## **Frodsham Solar**

### **Response to Local Planning Authority and Statutory Environmental Body Relevant Representations**

PINS Ref: EN010153

Document Ref: EN010153/DR/8.5

CROSSING CP14 PROPOSED SECTION B-B  
1:50

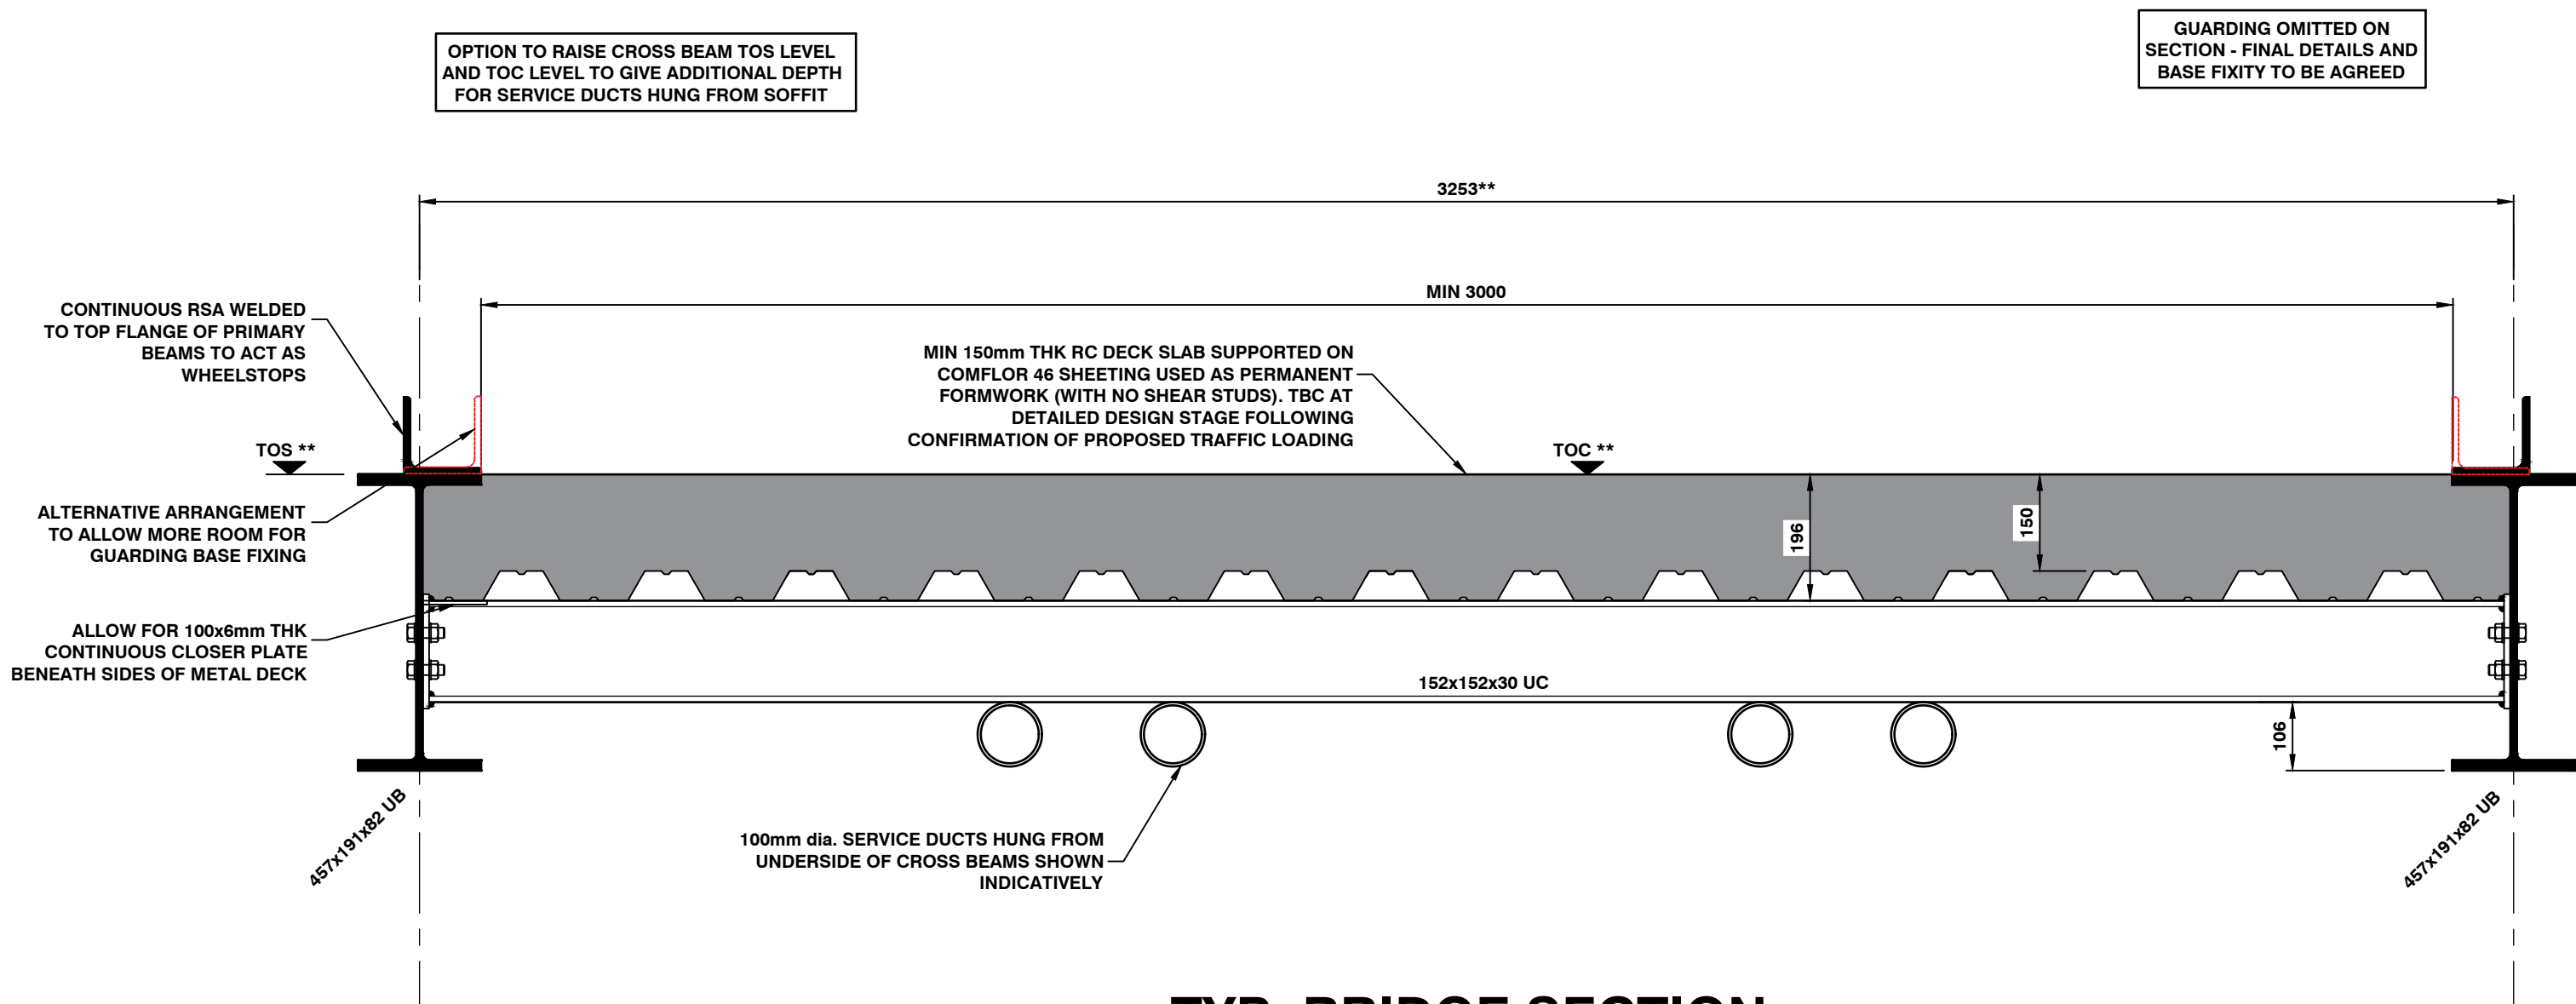
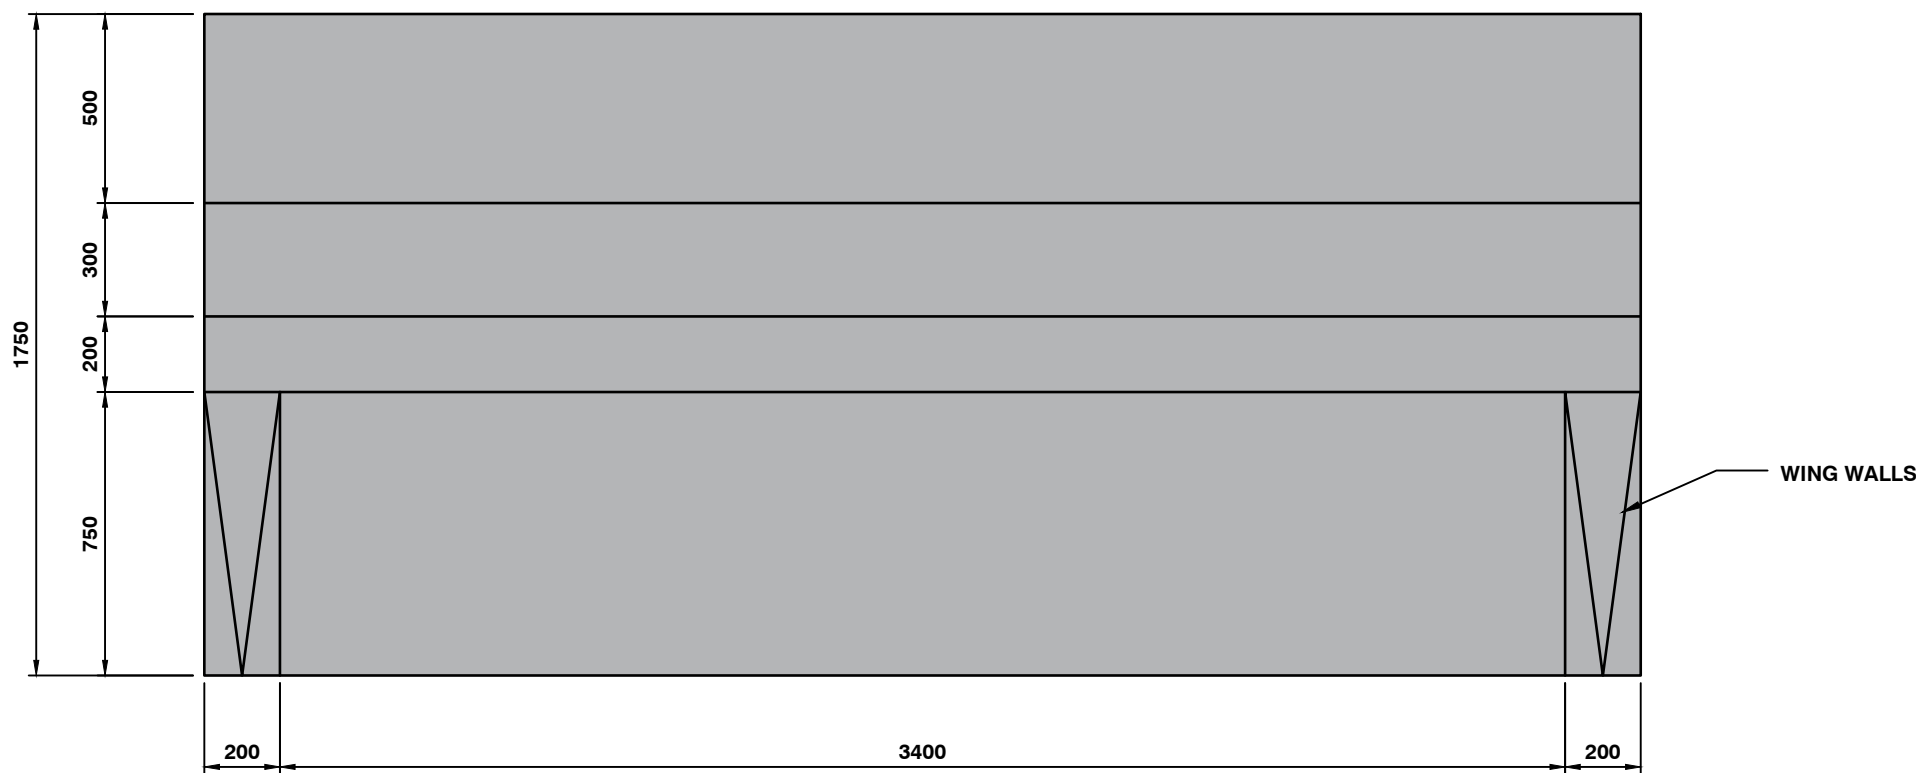
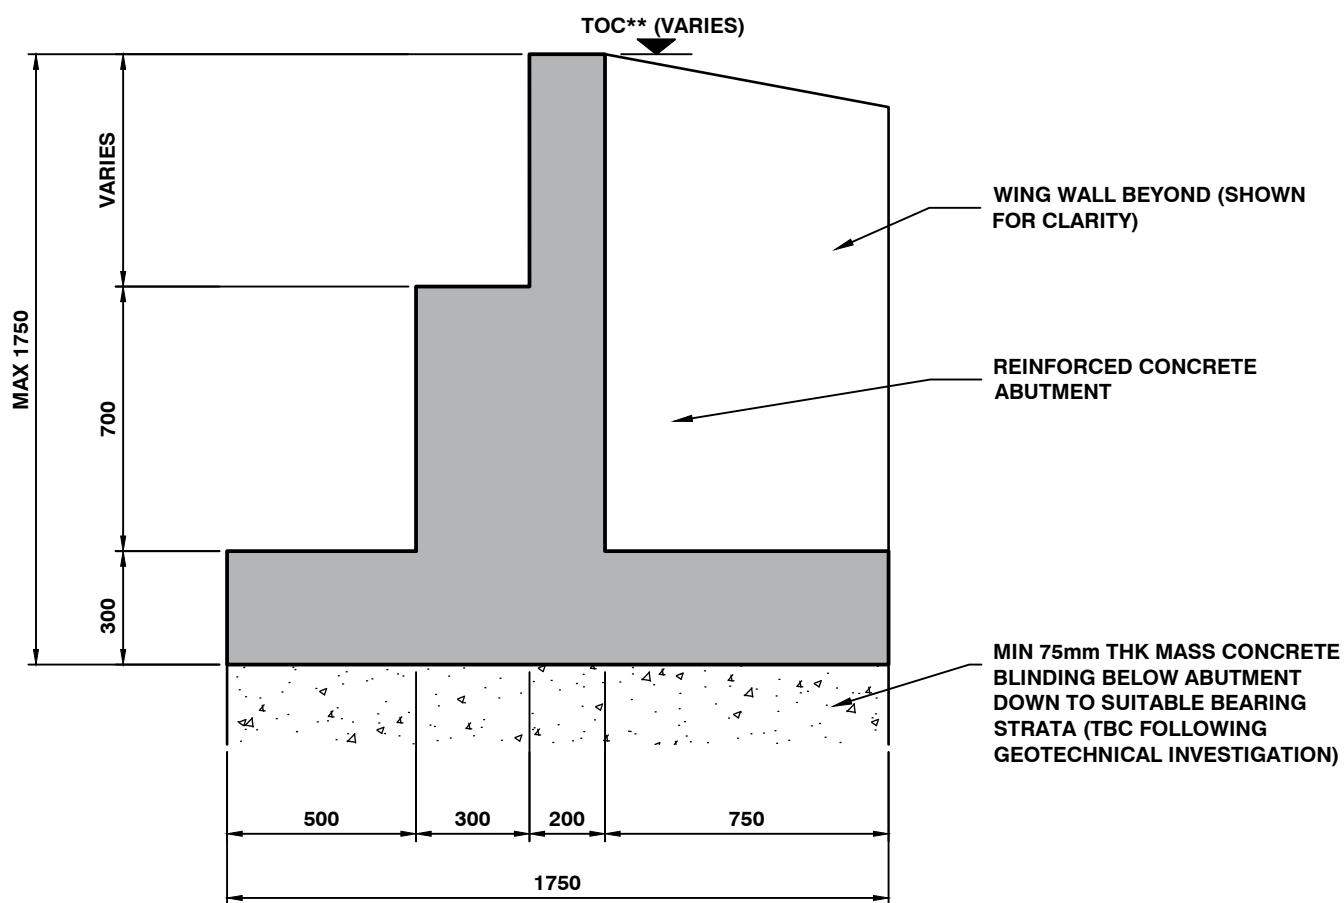
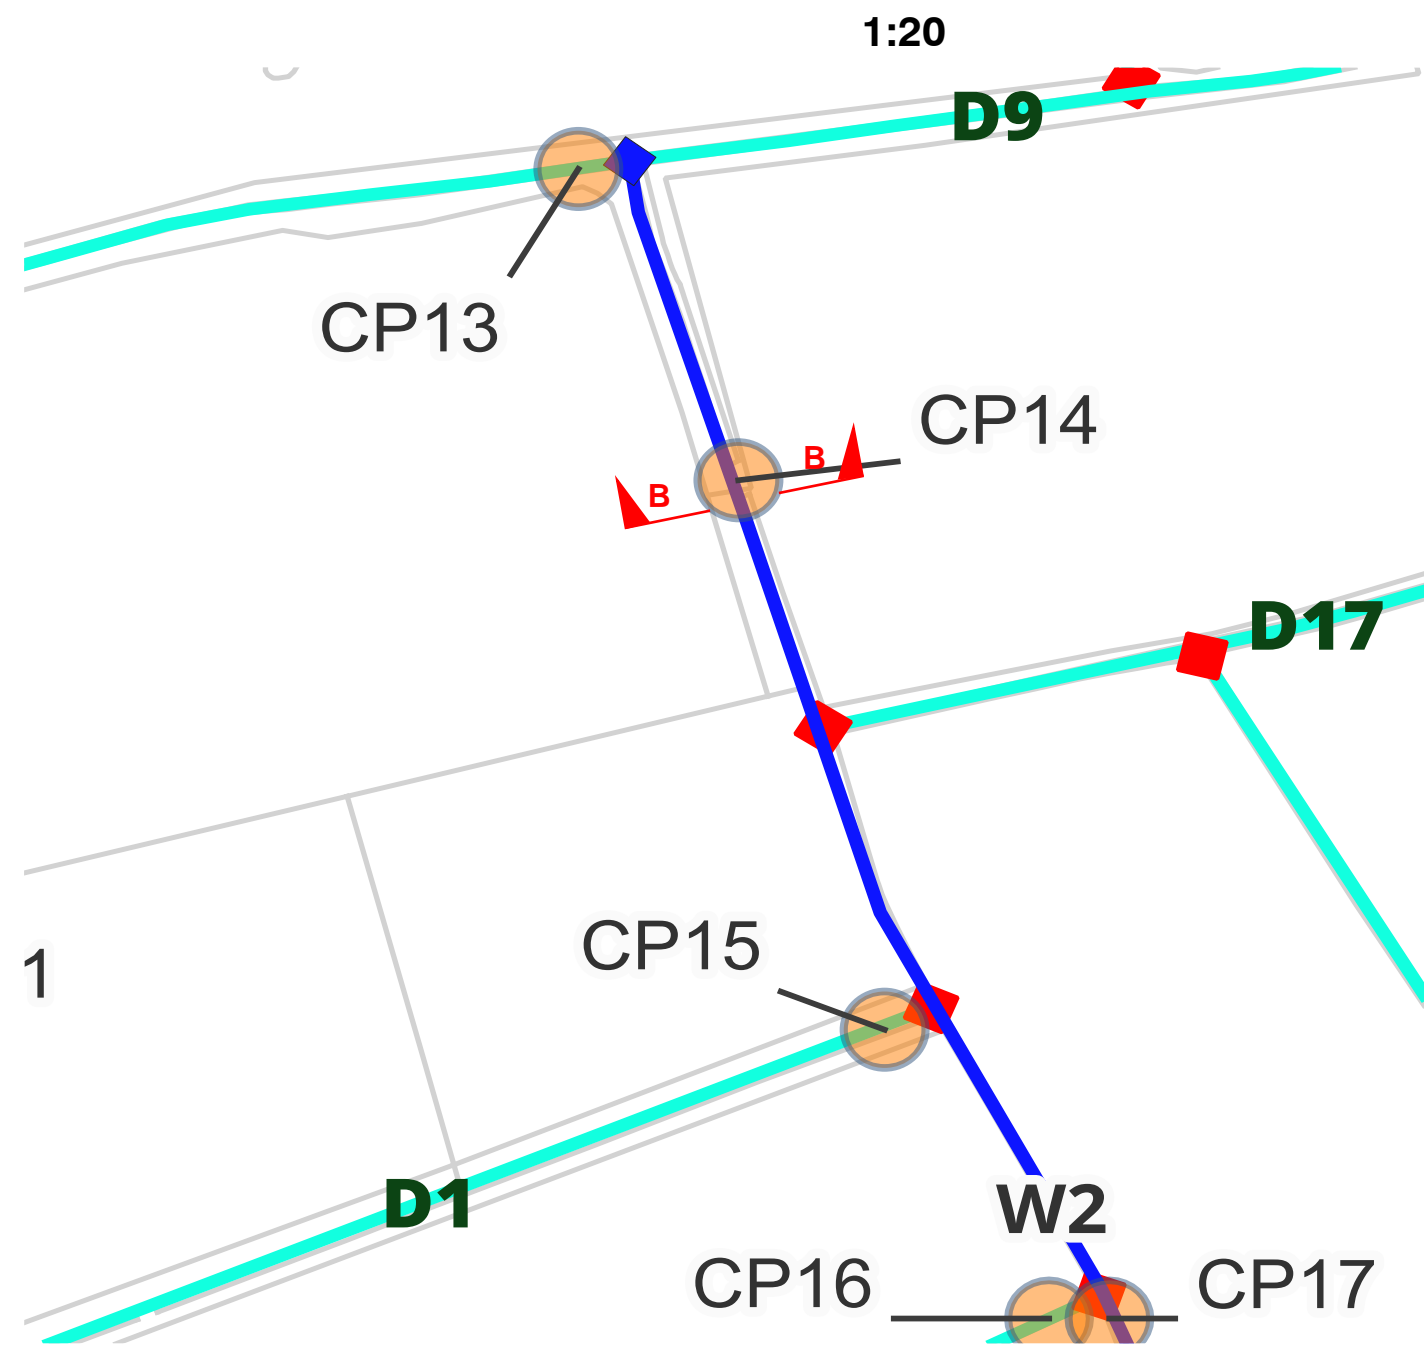
<b>Section/ pages/ table reference:</b>  Figure 2-5j (APP-042)  Table 5-3 (APP-136)	<b>Issue</b>	The position of bridge abutments and soffit level.
	<b>Impact</b>	Will reduce conveyance of water during high flow conditions, preclude access to, and threaten the stability of the riverbanks.  Additionally, this may cause damage to ecological processes and species, leading to a deterioration in WFD water quality.
	<b>Solution</b>	Setback bridge abutments at-least 2m from the bank top edge and increase the soffit level to at least 0.6metres higher than the top of the bank on both sides of the river.  Either through a commitment, or a requirement in the DCO, we require the following: <ul style="list-style-type: none"> <li>• Detailed drawings of crossings for each main watercourse (to scale including the design flood level + 600mm above bank level, as stated in guidance).</li> <li>• Drawings of existing culverted crossings at CP14 and CP22</li> <li>• Confirmation of the width of the deck of each crossing</li> </ul>

Figure 2-5j – Indicative Permanent Watercourse Crossings is observed to have bridge abutments on/close to the bank top edge.

ABUTMENTS SET BACK MIN 2m FROM TOP OF EXISTING BANK AND MIN 600mm FREEBOARD ABOVE EXISTING TOP OF BANK LEVEL (WHERE PRACTICALLY POSSIBLE). PRINCIPLES APPLY TO ALL NEW AND REPLACEMENT CROSSINGS
